RECALL: THIS MODIFICATION HAS TOP PRIORITY AND MUST BE PERFORMED IMMEDIATELY TO ENSURE CUSTOMER SAFETY

SIDE STAND SPRING AND SIDE STAND SENSOR RETAINING PLATE REPLACEMENT

2025 390 SMC R
2025 390 ENDURO R
2025 390 ADVENTURE R
2025 390 ADVENTURE X

Fig. 1 – Installation position of side stand spring no. 16, position of side stand sensor retaining plate no. 1

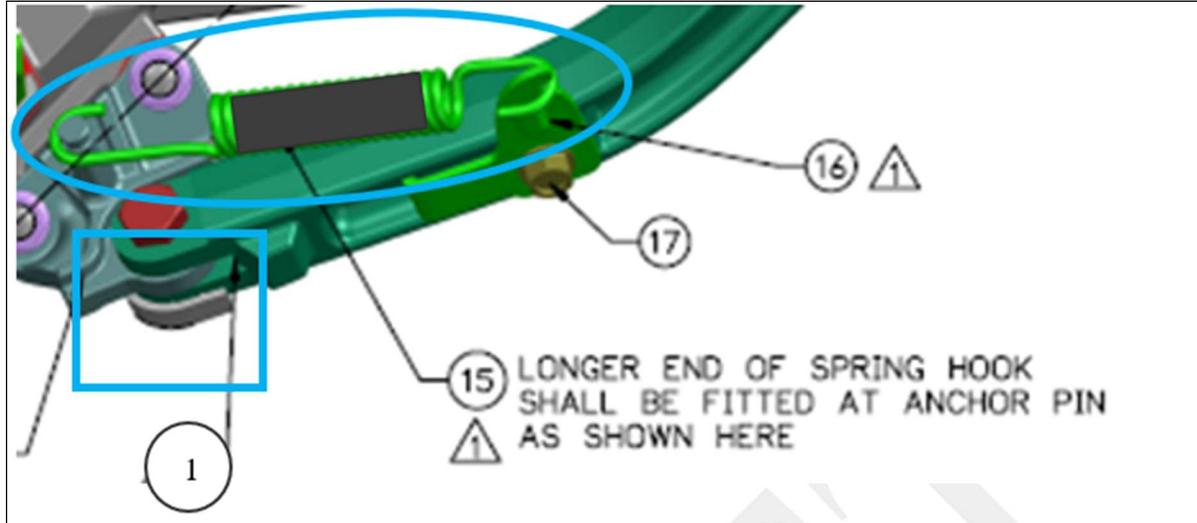
Caution:
As damage to the currently installed side stand spring cannot be ruled out, it must be replaced and must not be reused.
- Remove the side stand, including the special nut M10X1.25 (#J910001000700) and the special screw M10X1.25XL39XBLXST (#J9000010040U0).
- Remove the side stand sensor retaining plate (#A60103029000 , No. 1 in Fig. 1) and render it unusable.
- Install the new side stand sensor retaining plate (#A60103029100). To do this, first degrease the side stand in the installation area and remove the film from the new side stand spring retaining plate.
- Install the special screw (#J9000010040U0) and nut M10X1.25 (#J910001000700) (see Table 1).
- Install the new side stand spring with rubber protector (#A60103224033).

Caution:
Note the installation position (see Fig. 1).
- Use Action Code (03_2599896_01) when submitting the TI claim. Attach photos of the removed original side stand spring and the side stand sensor retaining plate to the claim.

Fig. 2 – Comparison of side stand sensor retaining plate – detail of magnet

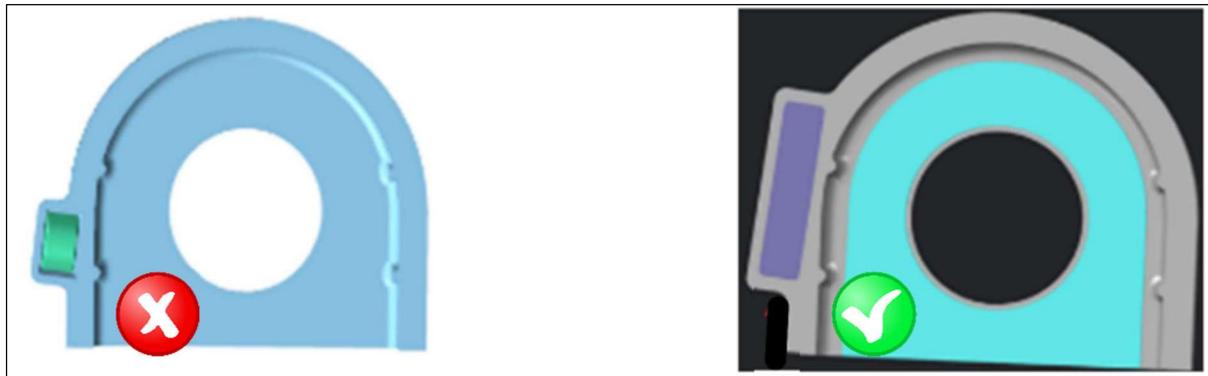
In addition to replacing the side stand spring affected motorcycles must also have a new side stand sensor retaining plate (**#A60103029100**) installed at the same time. The new side stand sensor retaining plate shifts the trigger range of the side stand switch.
